Minute No. 498
Report - Standing Policy Committee on Property and Development - June 8, 2004

Item No. 28 **Amendment to Development Agreement AG 42/87 - Canterbury Park Phase 2**
File DASZ 42/87

Re: Canterbury Park Phase 2 – DASZ 42/87

Map 1 to Report dated April 26, 2004 for AG 42/87

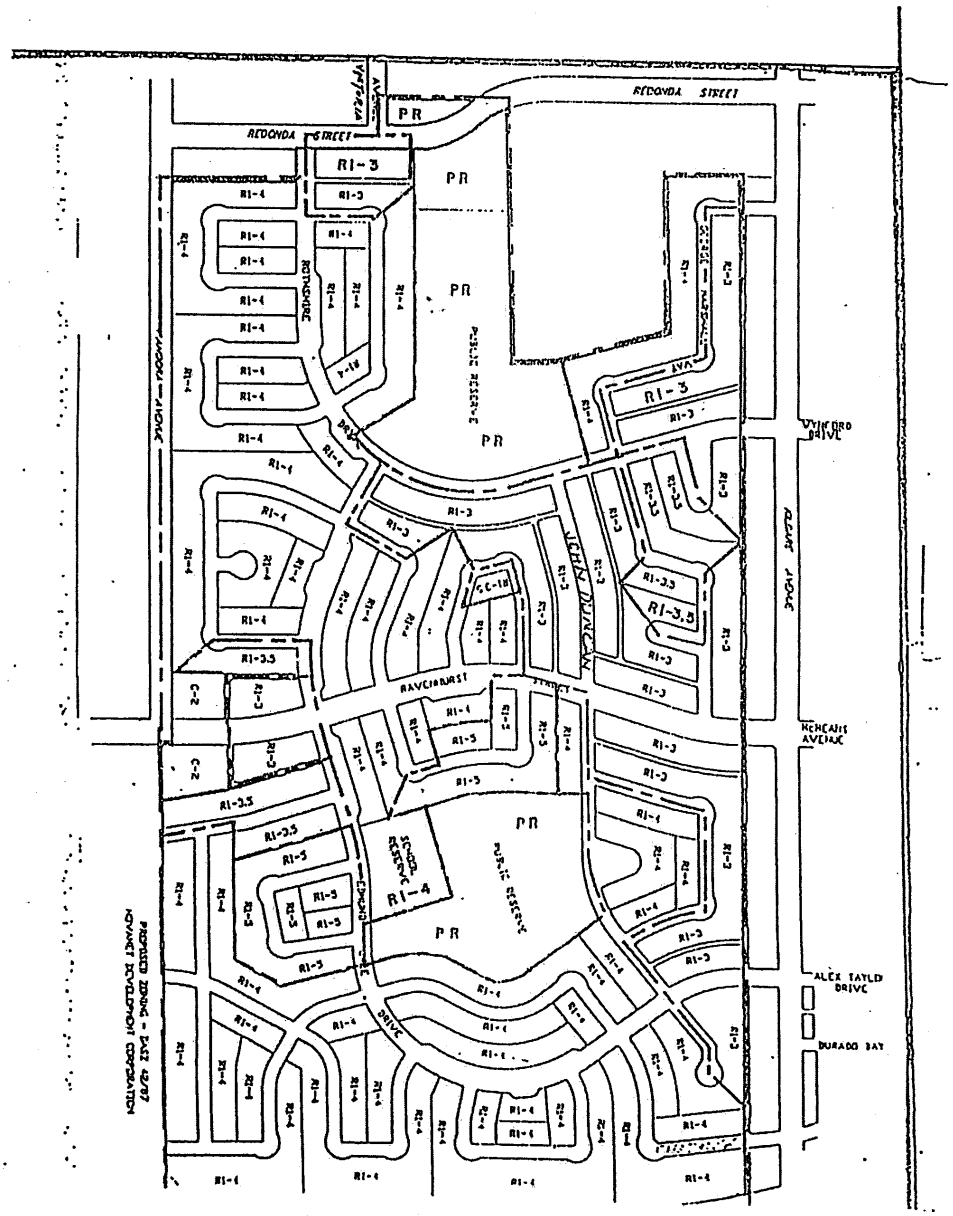
Council at its meeting held on May 31, 1989 approved DASZ 42/87 being an application by Novamet Development Corporation to subdivide and rezone approximately 240 acres of land located south of Kildare Avenue and east of Redonda Street. A copy of the approved plan is attached hereto and identified as Map 1. At the Developer's request, Council at its meeting held on August 2, 1989, approved the registration of the approved plan of subdivision in phases in accordance with the plan attached hereto and identified as Map 2. To date the following portions of the approved plan of subdivision have been registered:
